HOPE CREEK GENERATING STATION
DOCKET NO. 50-354
NRC REVIEW OF STRUCTURAL/GEOTECHNICAL TOPICS

Attachment: Resolution of NRC Comments on
Structural/Geotechnical Topics

Response to NRC Audit

January 10/8-5
 Page 7

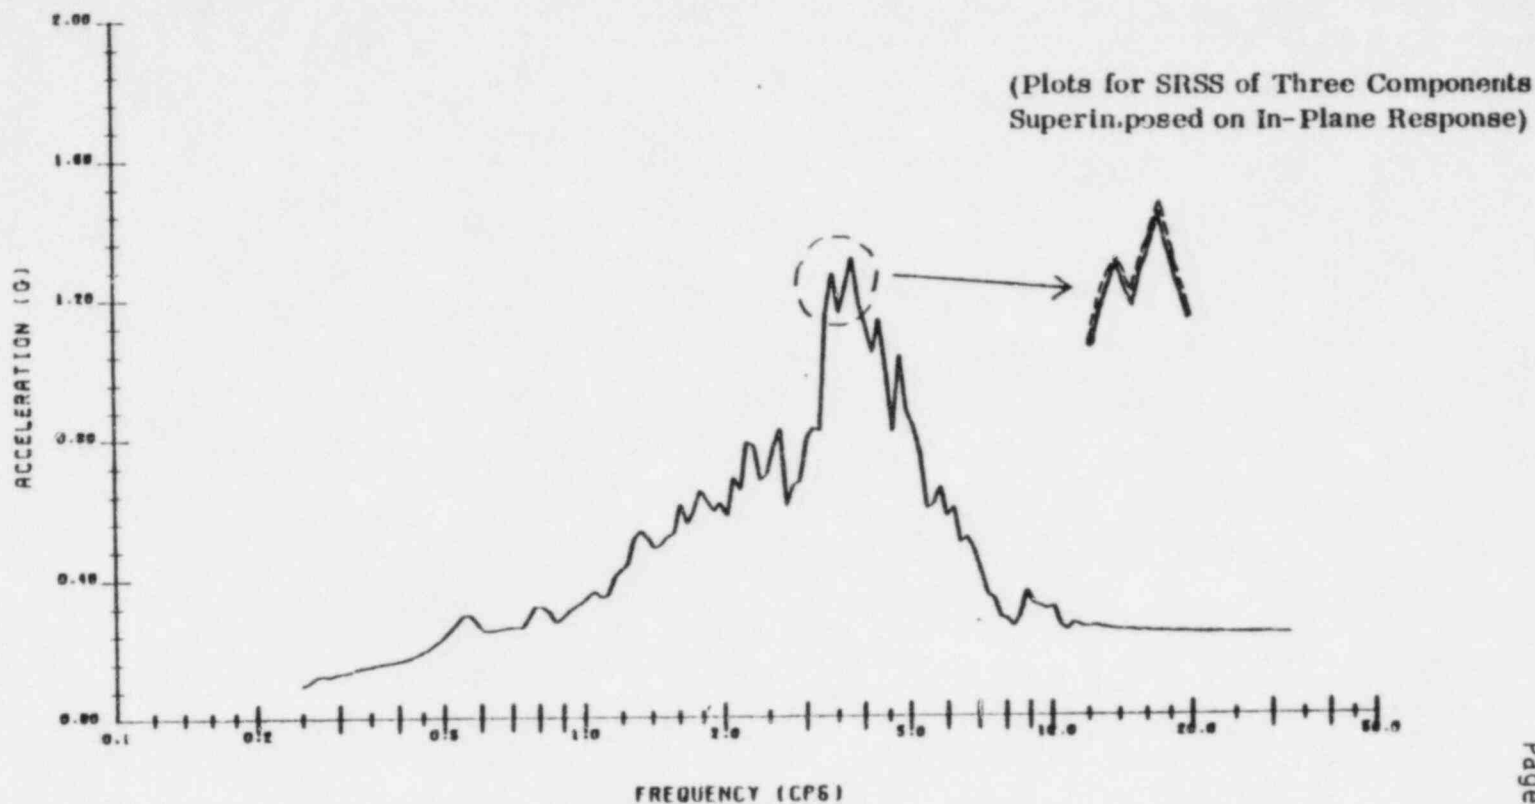
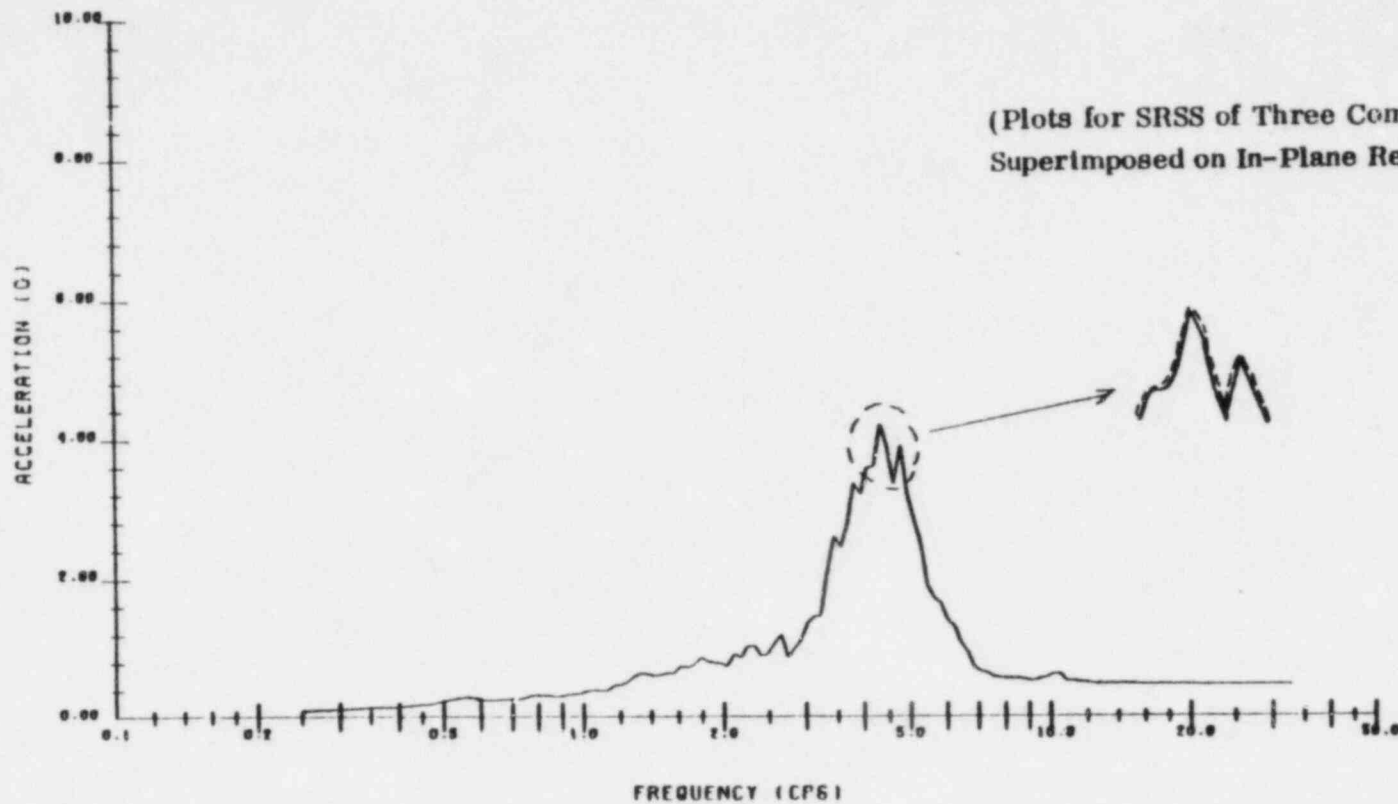
Question: Provide example calculation for combination of NS, EW, and vertical responses.

Response: As defined by the Regulatory Guide, the spectral accelerations for three earthquake components were summed at each frequency point using an SRSS-type procedure. As demonstrated by Figures B-216 through B-224, the out-of-plane components do not contribute significantly to the in-plane spectra, and were clearly not required for the development of the floor response spectra.

Portion of the SSI Model Representing
the Base-Mat Area

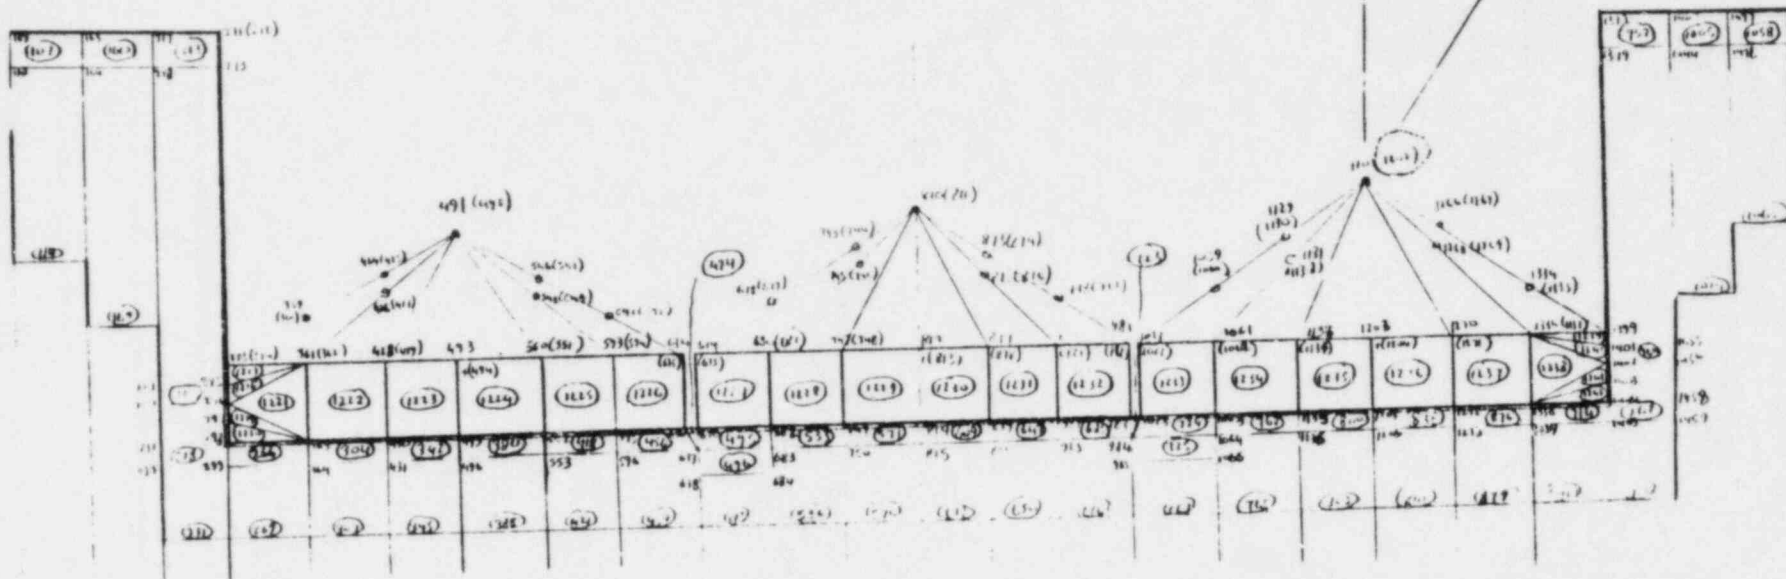
Provide calculations to show that rotational time history input $\phi(t)$ to detailed structural model is same as rotational time history $R(t)$ from SSI model.

Page 1 of the attachment shows the finite element representation of the model used for SSI analyses in the N-S direction. Node 1202 of this model corresponds to the rotational node at the base-mat elevation of the reactor building. Page 2 shows the maximum value of the rotational acceleration time history output for node 1202. Page 3 of the attachment shows the detailed model of the reactor building. The rotational response at node 107 (node at base-mat elevation) is shown on page 4 of the attachment. Comparison of the maximum value, and time at which it occurs, of the rotational time history response between nodes 1202 of SSI model and 107 of detailed structural model, shows that the response from the SSI model is the same as input to the detailed building model.

FINITE ELEMENT MESH FOR PROFILE B-B

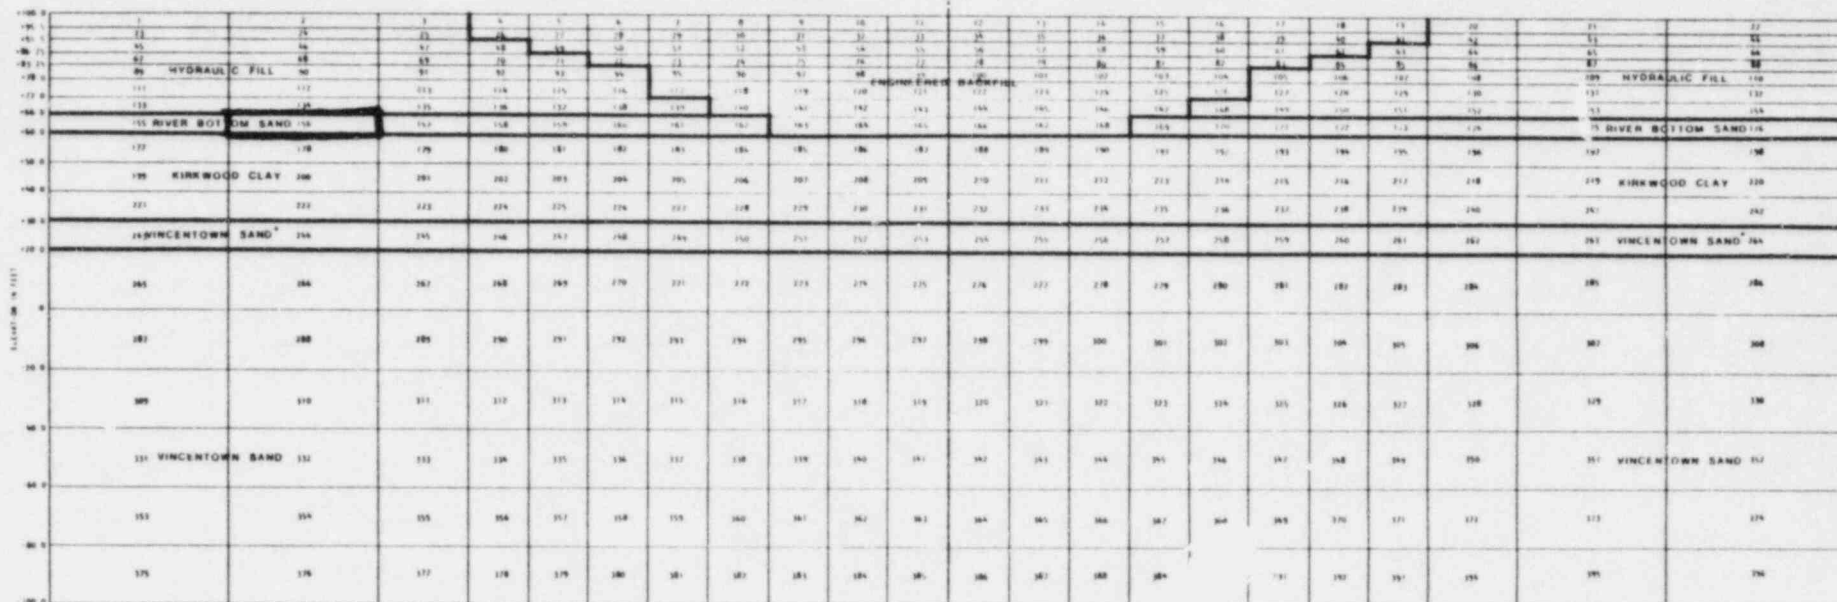
As discussed in the response to Item A-15 of the January 10, 1984 meeting, based on various methods of analyses (Ref. 2.5-79 and 2.5-114), the factor of safety against liquefaction of the river bottom sands is generally well above unity. The hydraulic fill materials are primarily cohesive, highly plastic, and will not be susceptible to liquefaction. (FSAR Section 2.5.4.8.3). As a result of the dynamic loading during an SSE, however, the pore pressure in the hydraulic fill will rise above the initial hydrostatic conditions. The maximum pore pressure increase in the river bottom sands and the hydraulic fill is equal to the corresponding effective vertical stress. Since the effective vertical stress in the hydraulic fill is less than that in the river bottom sands, it is unlikely that the excess pore pressure in the hydraulic fill would be large enough to cause liquefaction of the river bottom sand. Therefore, the pore pressure buildup in the hydraulic fill will not affect the previous conclusions regarding the liquefaction potential of the river bottom sands.

Element 156 of the Finite Element model on Figure 4.2 represents a typical element of the River Bottom sand layer in "Free Field".

Due to approximately "Free Field" conditions, the σ'_c value (effective normal stress on the potential failure plane - in this case near horizontal) is 1820 psf. This corresponds well with the estimated effective vertical stress as shown on the attached sheet.

Based on Figure A-19A of Reference 2.5-96, the average stress ratio causing $\pm 2.5\%$ axial strain in 5 cycles for the river bottom sands is 0.55.

MATHEMATICAL MODEL OF FREE FIELD SOIL COLUMN
FOR DECONVOLUTION ANALYSIS

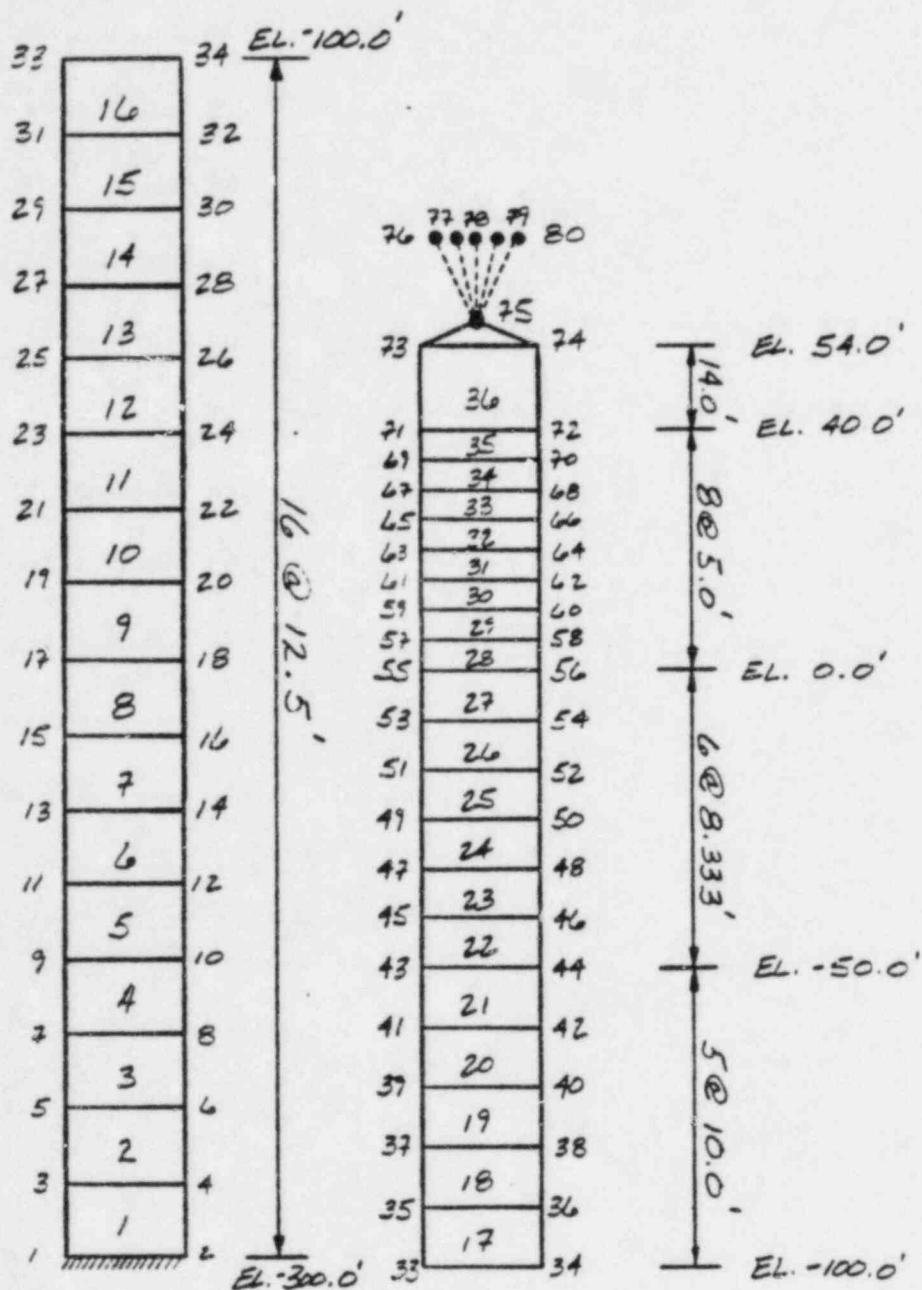
QUESTION: Justify the 12 Hz. cut-off frequency for SSI analysis.

A soil column, representing the Hope Creek free-field soil properties, was first constructed. The mesh refinement was selected such that a wave frequency of 20 Hz. could be transmitted without loss of numerical accuracy. A schematic representation of the soil column model is presented in Figure 1.

The free-field soil column is composed of a series of two-dimensional plane strain elements of unit width modeling the soil properties. The dimensions of the soil column extend between elevations 102.0 feet, corresponding to the elevation at finished grade for the Hope Creek site, down to elevation -300.0 feet, a depth found to be sufficiently deep to include all significant soil-structure interaction effects.
